SI B63 07 16
Lights

WATER INSIDE REAR LIGHT ASSEMBLY

This Service Information bulletin replaces SI B63 07 16 dated **October 2016**

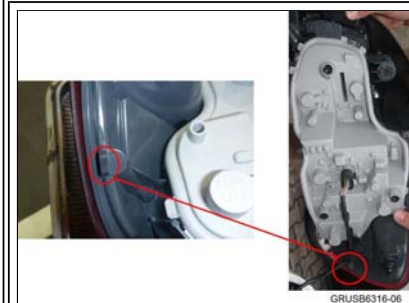
2. Detach the spacers on both sides of the vehicle body if present and dispose of them.

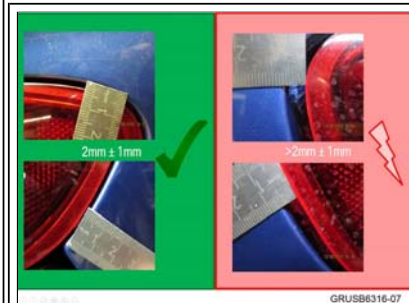
3. Obtain new (modified) rear lights (same part number). Updated part has no black cap on bulb socket.

4. The new light assembly has the spacer fitted as shown.
5. Install the new rear lights according to the REP 63 21 260.

6. Verify position, symmetry and gap dimensions. Does the installation have gaps of 2mm +/- 1mm?
YES- repair is complete.
7. NO – go to next step
8. Remove spacer attached in step 4.
9. Reinstall the rear light assembly according to REP 63 21 260.
